ADDENDUM #1 TO BID #24-045

BID NUMBER: 24-045

PROCUREMENT FOR: Georgetown County Roof Replacements & Repairs

HOWARD CORE SAMPLE PHOTOS

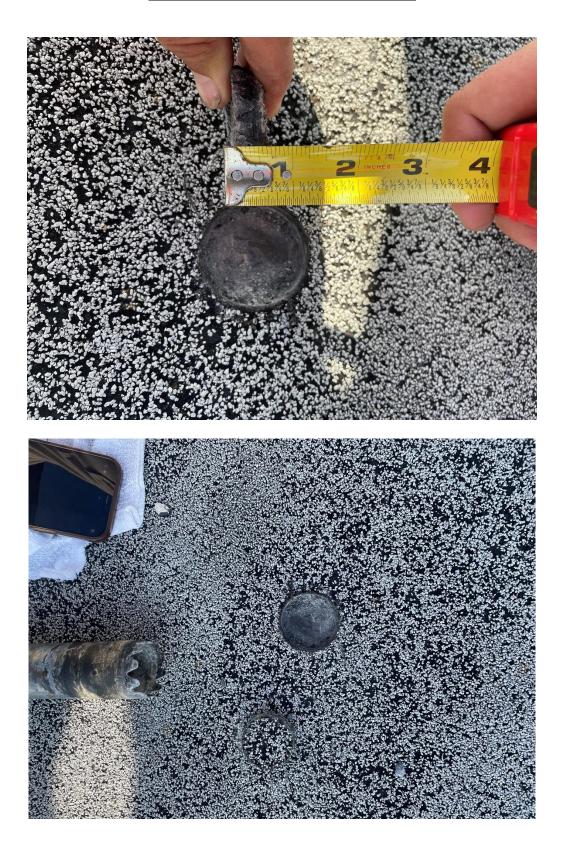
Question 14: Do you have core samples?

Response: Attached are the pictures of the core samples that were taken during the prebid meeting site visit.
